**Creek Restoration
Swanson Hydrology + Geomorphology,**

Project: Hillside House Development Project **Date:** August 20, 2008;
Revised January 16, 2009

Subject: **City comments on proposed Conceptual Enhancement Plan for Arroyo Burro Creek (August 2008)**

Project: Hillside House Development Project **Date:** January 25, 2008
To: Lisa Plowman, Peikert Group Architects
From: Kevin Fisher, Senior Restoration Ecologist; Rodney Cahill, Senior Engineer
Subject: Revised Conceptual Enhancement Plan for Arroyo Burro Creek

CROSS
SECTIONS

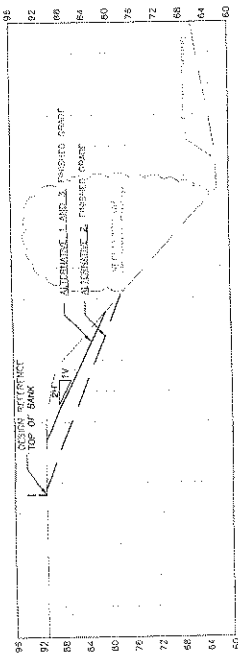
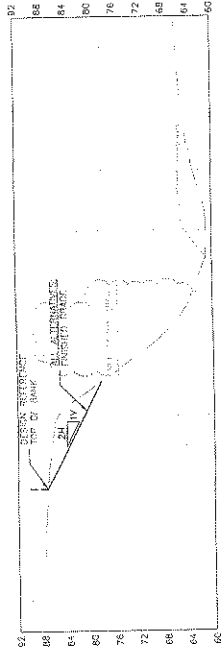
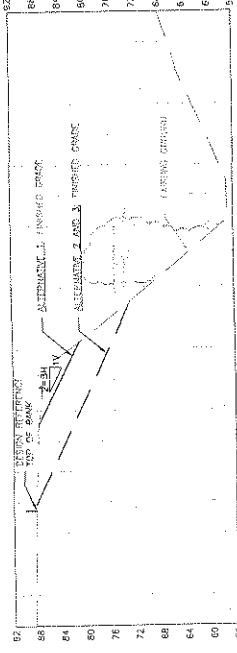
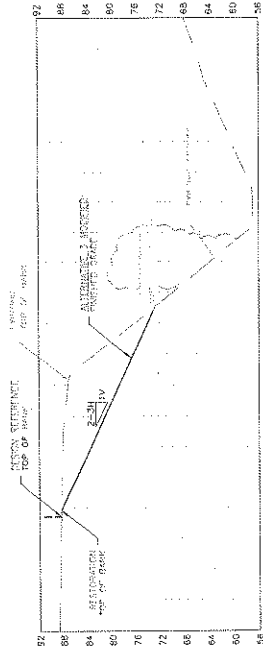
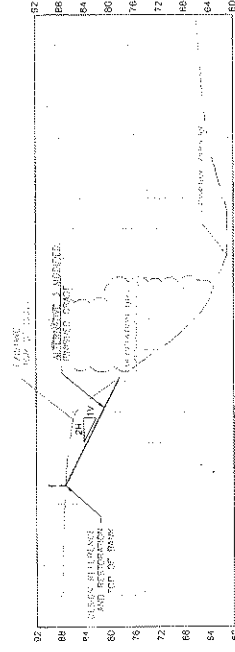
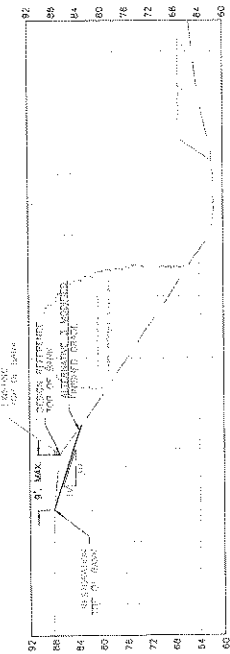
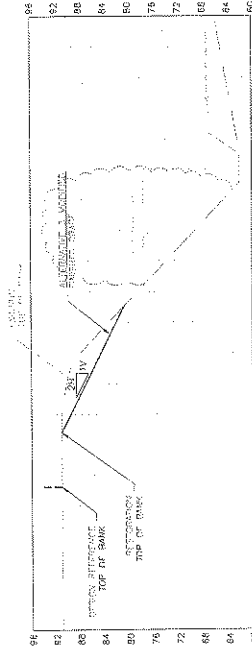
Comment: *Explain why the grading and replanting is started mid slope rather than at the toe of the slope.*

Response: In a technical memorandum dated November 7, 2007 Swanson Hydrology + Geomorphology (SH+G) presented three conceptual enhancement alternatives for Arroyo Burro Creek and identified Alternative 3 as the preferred plan. The City staff agreed that Alternative 3 would be the preferred plan, but asked SH+G to consider the benefits of additional grading along the left channel bank. SH+G reviewed the proposed grading plan for Alternative 3 in the context of geomorphic conditions and engineering constraints at the Project site. **Attachment 1** shows a revised conceptual grading plan for the creek corridor. The revised grading plan has additional grading at the top of slope which would be beneficial for bank stability, riparian enhancement and aesthetics. This plan would grade the over-steepened upper bank throughout the length of the Project. The depth of grading would range from approximately 3 to 8 feet below the current top of bank. Upper bank slopes that are currently near vertical would be graded to range from 2H:1V to 3H:1V. The revised plan would grade an additional 120 cubic yards of material from the over-steepened banks, resulting in total excavation volume of 840 cubic yards.

Revegetation at the toe of slope is only proposed in areas where giant reed or other invasive, non-native species will be removed. Mapping of these areas will be refined in the next phase of developing the Enhancement. Planting is not proposed in portions of the lower bank that are already dominated by native species.

SH+G did not analyze the scenario of grading from the toe of slope because this would preclude development of a significant portion of the Project area due to geotechnical constraints. We speculate that there could be positive and negative outcomes of grading from the toe of slope. While grading from toe would expand the riparian corridor it would have significant impacts on existing riparian habitat established at the toe and mid slopes. This type of grading could also induce new instability by forming discontinuities in channel hydraulics and sediment transport through the reach leading to undesirable or unforeseen conditions such as excessive sediment deposition and/or erosion.
